SERVICE BULLETIN

No. 193

SUBJECT: Modification of Fuel Cell Vent Tube

MODELS AFFECTED: PA-24 and PA-24-250 Comanches Serial Nos. 24-1 to 24-2161 inclusive

FUEL CELL VENT TUBE

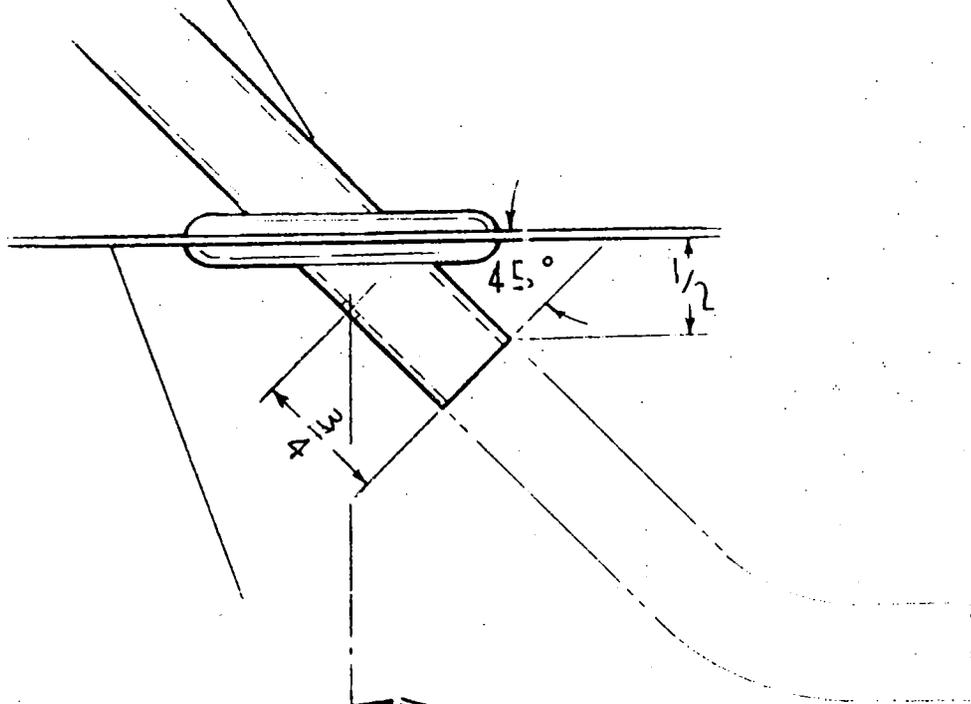
A .098 hole is to be drilled in each of the vent tubes as shown on the sketch on the reverse side of this bulletin.

This modification will minimize the possibility of any interruption of the fuel flow in the event that the opening of the vent tube should become obstructed.
